## ADDENDUM NO. 1

May 19, 2022

Newell Lake Dam Spillway Replacement  
GFP Project No. News22Wa

Owner: State of South Dakota  
Department of Game, Fish and Parks

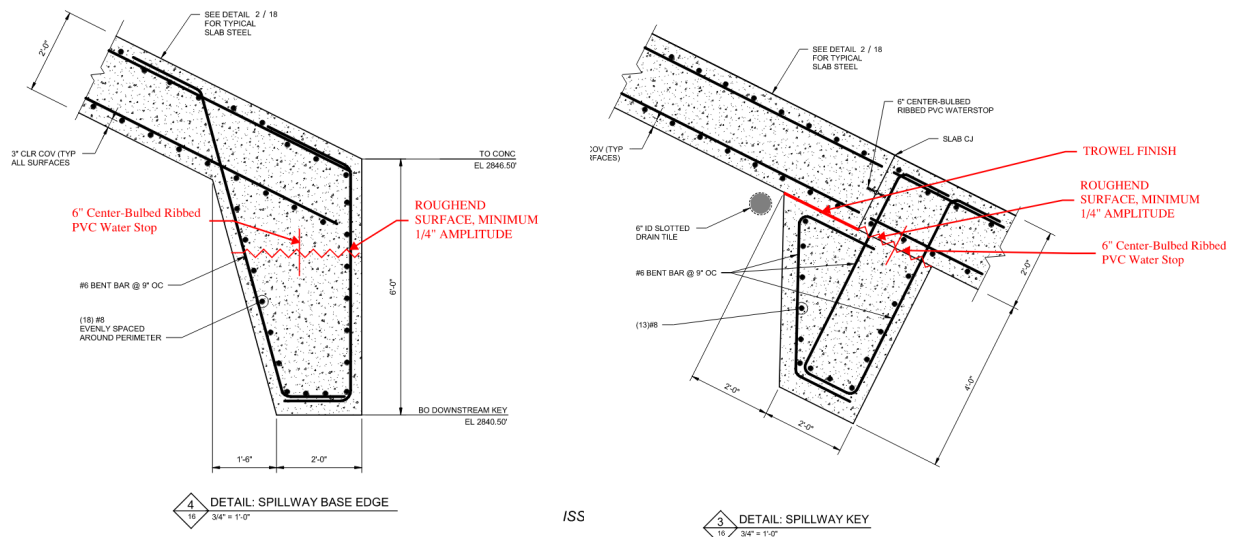
Item No. 4: **Question:** Can we break up the thickened edge section and spillway base edge section into two parts, the thickened piece and then the slab piece with waterstop between? Attached is a marked-up version of the plan sheet to help clarify the parts in question.

**Answer:** This is acceptable, see below.
